# Office Action Summary

10/572,511

MASUDA, MASANORI

**DETAILED ACTION**

Figure 1

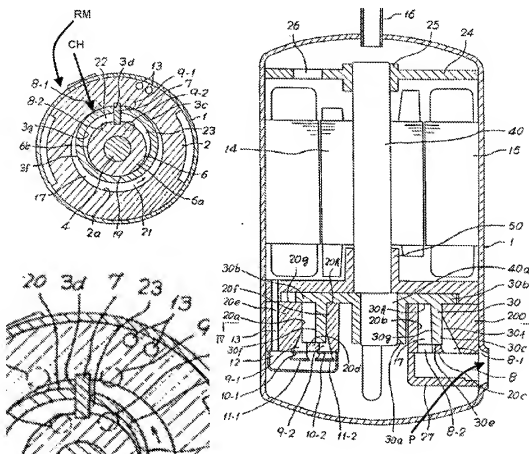
3. In re claim 1, with reference to figure 1 below, Mitsubishi discloses a rotary compressor comprising:

- a rotation mechanism (RM) including a cylinder (2) having an annular cylinder chamber (CH);
- an annular piston (3c) disposed in the cylinder chamber to be eccentric to the cylinder, the annular piston dividing the cylinder chamber into an outer compression chamber (23) and an inner compression chamber (20, 21); and
- a blade (7) disposed in the cylinder chamber (CH) to divide each of the inner and outer compression chambers (20, 21, 23) into a high-pressure side (20, 21) and a low-pressure side (23), the rotation mechanism compressing a fluid by relatively rotating the cylinder and the piston,
- one of the inner and outer compression chambers being a low-stage side compression chamber for compressing a low-pressure fluid into an intermediate-pressure fluid, and the other of the inner and outer compression chambers being a high-

4. In re claim 2, with reference to figure 1 above, Mitsubishi discloses the rotary compressor wherein the outer compression chamber (23) serves as the low-stage side compression chamber, and the inner compression chamber (20, 21) serves as the high-stage side compression chamber.
5. In re claim 5, Mitsubishi discloses the rotary compressor further comprising:
  - a casing (1) containing the rotation mechanism (RM), the casing forming an intermediate-pressure space (8) into which the intermediate-pressure fluid compressed

9. In re claim 3, with reference to figure 1 above, Mitsubishi discloses the rotary compressor comprising a casing containing the rotation mechanism (1), the casing forming an intermediate-pressure space (8) into which the intermediate-pressure fluid compressed in the low-stage side compression chamber is introduced; but fails to disclose a gas injection pipe connected to the casing and configured to accommodate a gas that is injected into the intermediate pressure space.

23. In re claim 8, with reference to figure 1 above, Mitsubishi discloses the rotary compressor wherein:

- the piston (3c) is C-shaped to form a gap,

- the blade (7) extends from an inner peripheral wall surface of the cylinder chamber to an outer peripheral wall surface thereof and passes through the gap of the piston, and

24. However, while the surface is rounded, Mitsubishi fails to disclose the gap has a swing bushing contacting the piston and the blade therein such that the blade is reciprocable and the blade is swingable relative to the piston.

30. Nevertheless, with reference to figure 1 above, Mitsubishi discloses:

- an annular piston (3c) disposed in the cylinder chamber to be eccentric to the cylinder, the annular piston dividing the cylinder chamber into an outer compression chamber (23) and an inner compression chamber (20, 21); and

- a blade (7) disposed in the cylinder chamber (CH) to divide each of the inner and outer compression chambers (20, 21, 23) into a high-pressure side (20, 21) and a low-pressure side (23), the rotation mechanism compressing a fluid by relatively rotating the cylinder and the piston,

Figure 2

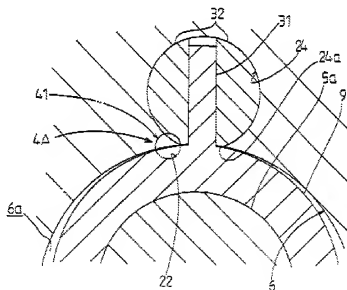
25. Nevertheless, Saitou (6,077,058) with respect to figure 2 below, discloses "the driving shaft in a cylinder room with supported by a swing bush (32) as a supporting point though a blade (31) (line 2, abstract). This feature allows the blade and the eccentric piece to rotate easier.

26. Therefore, it would be obvious to one having ordinary skill in the art at the time of the invention to modify Mitsubishi in view of Saitou by using the swing bush of Saitu in the compressor of Mitsubishi in order to aid the blade's and eccentric piece's movement.

**Figure 3**

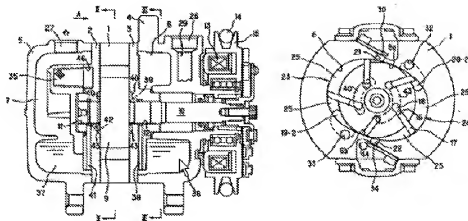
28. In re claim 1, Seiichiro discloses with reference to figure 1 above and 3 below, a rotary compressor comprising [see figure 3]:

- a rotation mechanism including a cylinder (1) having an annular cylinder chamber (25);

29. However, Seiichiro fails to disclose:

- an annular piston disposed in the cylinder chamber to be eccentric to the cylinder, the annular piston dividing the cylinder chamber into an outer compression chamber and an inner compression chamber; and
- a blade disposed in the cylinder chamber to divide each of the inner and outer compression chambers into a high-pressure side and a low-pressure side, the rotation mechanism compressing a fluid by relatively rotating the cylinder and the piston,
- one of the inner and outer compression chambers being a low-stage side compression chamber for compressing a low-pressure fluid into an intermediate-pressure fluid, and the other of the inner and outer compression chambers being a high-stage side compression chamber for compressing the intermediate-pressure fluid compressed in the low-stage side compression chamber into a high-pressure fluid.

33. In re claim 2, with reference to figure 3 above, Seiichiro/Mitsubishi fails to disclose which chamber yields the high and intermediate pressure. The rotary compressor wherein the outer compression chamber (23) serves as the low-stage side compression chamber, and the inner compression chamber (20, 21) serves as the high-stage side compression chamber.
